IN THE DRAWINGS

1 REMARKS 2

This amendment responds to the Office action of September 10, 2007. Applicants 3

FIGURE 1 - Prior Art

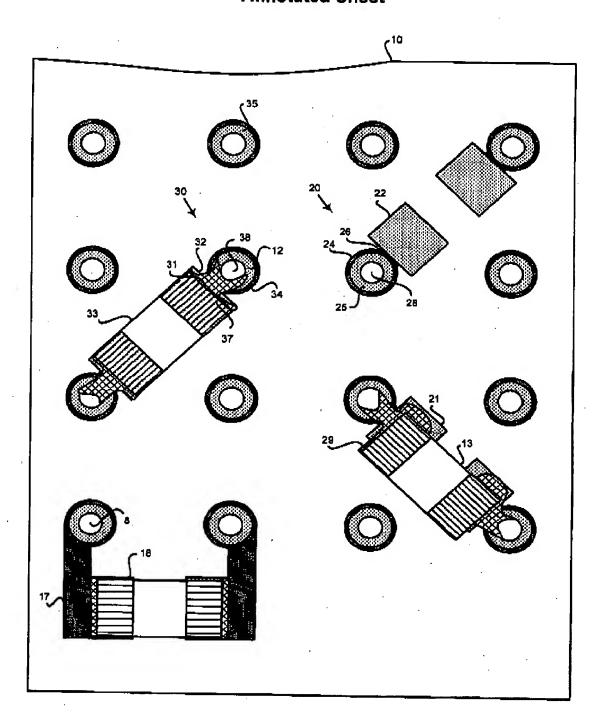
The Examiner also suggests Figures 1 and 2A-2B be designated prior art. Applicants designate drawing Figures 1 and 2A-2B as prior art.

- 2 The enclosed replacement sheets are intended to replace the original sheets of Figure 1
- 3 and 2A-2B. Applicants designate each of the enclosed annotated sheets of Figures 1
- 4 and 2A-2B with the legend "prior art."
